<b>Subject:</b>  REAR CONSOLE LID DOES NOT LOCK	<b>Bulletin No:</b> 09-039/16
	<b>Last Issued:</b> 06/14/2016

2016 CX-5 vehicles with VINs lower than JM3KE\*\*\*\*\*736277 (produced before October 31, 2015)

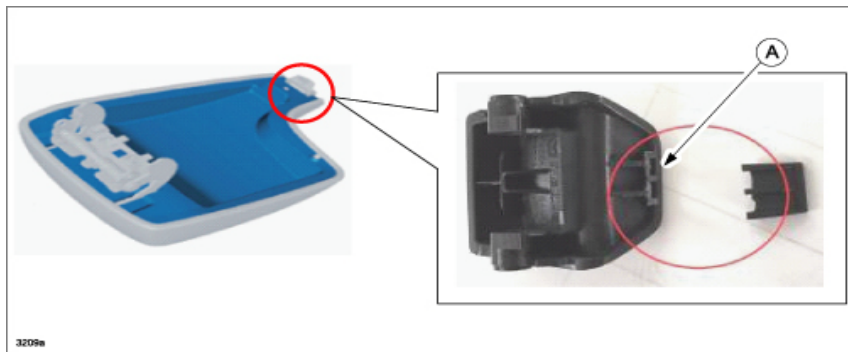
Some vehicles may have a rear console lid that cannot be locked due to a broken latch (A).

The rear console lid latch may be broken by excessive force applied to the lid. To eliminate this concern, the shape of the rear console lid latch has been changed to increase its strength.

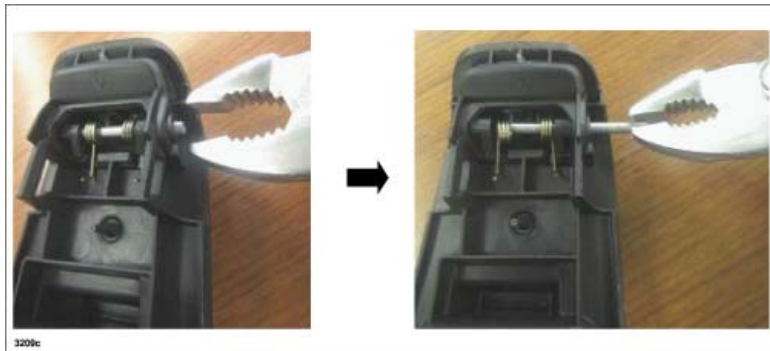
1. Verify the customer concern.
2. Remove the console lid and inner cover according to the instructions on MS3 online or the Workshop Manual (section 09-17 CONSOLE LID REMOVAL/INSTALLATION).

**NOTE:** Apply protective tape (A) to the tip of a screwdriver. Insert the screwdriver into the space between the console lid and the inner cover.

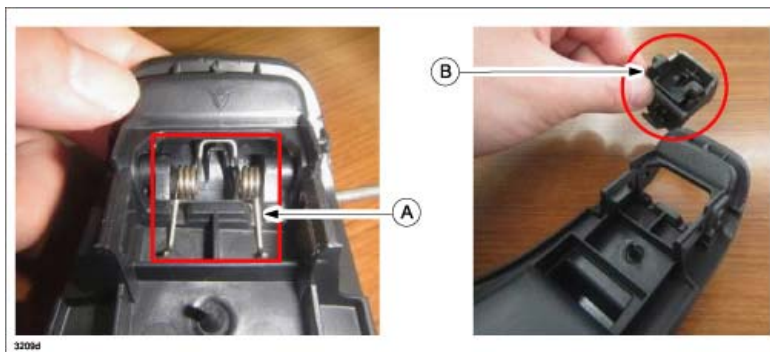
4. Remove the spring (A) and the console lid lock (B).

5. Install a new (modified) console lid lock, then the other removed parts in reverse order.  
**NOTE:** Verify that the lock can move smoothly before installing the console lid onto the inner cover.
6. Verify the repair.
